SERVICE BULLETIN

Notification Number	SB-22-10-6
Subject	Fuel Line Support Clamp Verification
Supersedes Notices	
Release Date	October 6, 2022
Effective Date	October 6, 2022
Required Corrective Action	One Time Verification
Affected Make	American Legend Aircraft
Affected Models	AL3 – 2018 or later, AL18 -All
Affected Serial Numbers	ALL

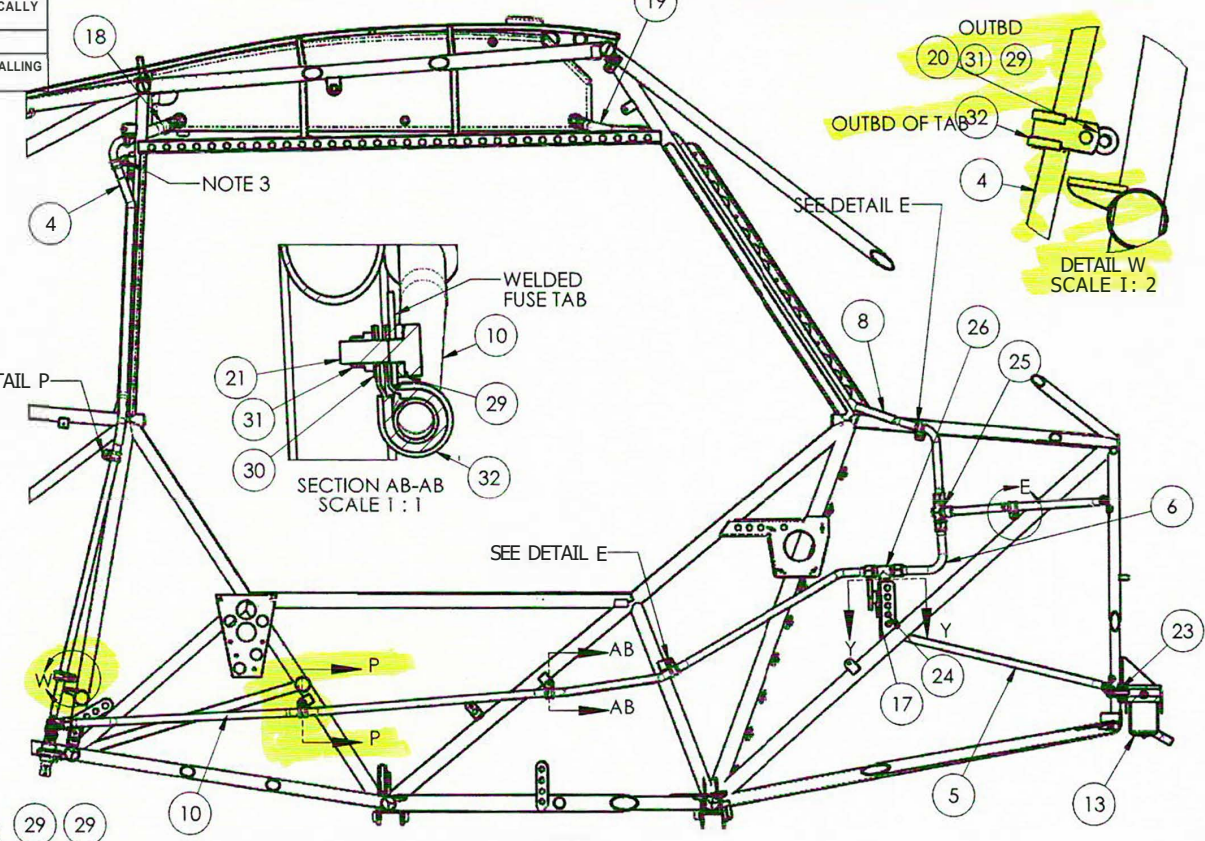
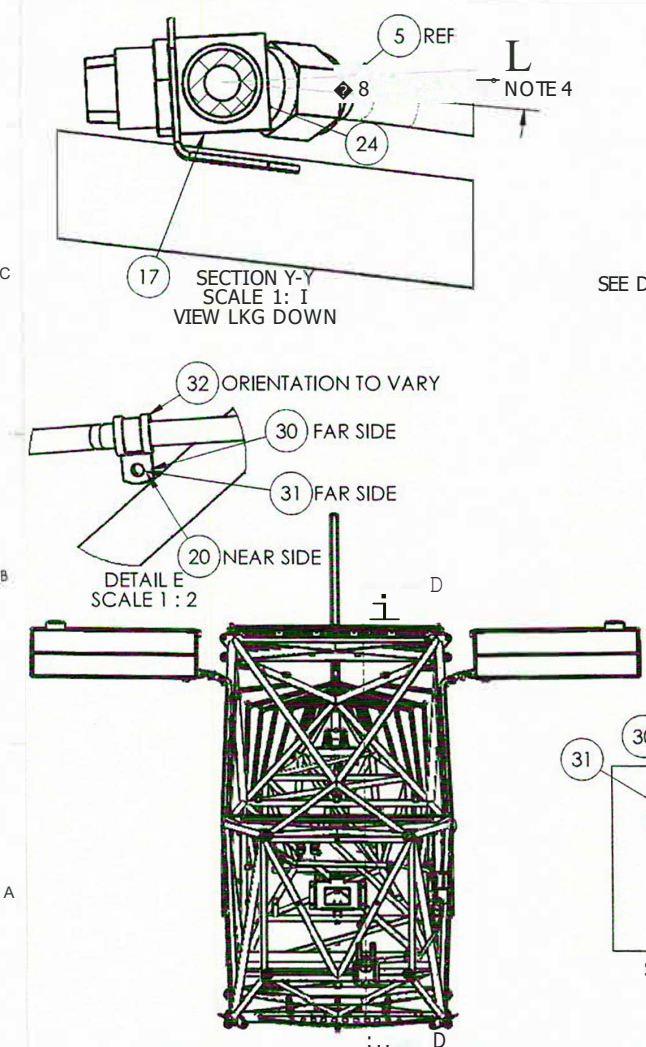
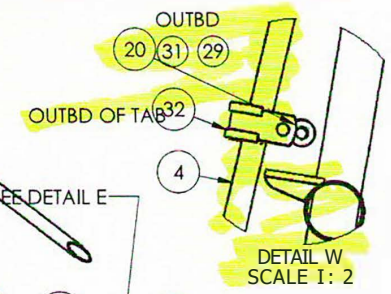
It has been found that the 2 aft main fuel lines, at both sides of the passenger seat could get pushed downward and come in contact with the rudder cable, due to a missing support clamp (see detail on fuel line installation drawing 150-PP0101. If the clamp is missing, install clamp as indicated. Also, examine the lines to ensure the clamps securely support the line and for signs of chafing or rubbing from the rudder cables. Replace fuel lines that show indications of chafing.

Kits containing this material can be ordered from American Legend Aircraft Company. Kit part number SB-22-10-6, 1 Each of the following. Bolt AN3-4A, Washer(s) AN960PD10, AN960PD10L, and Adel clamp MS21919WDG6.
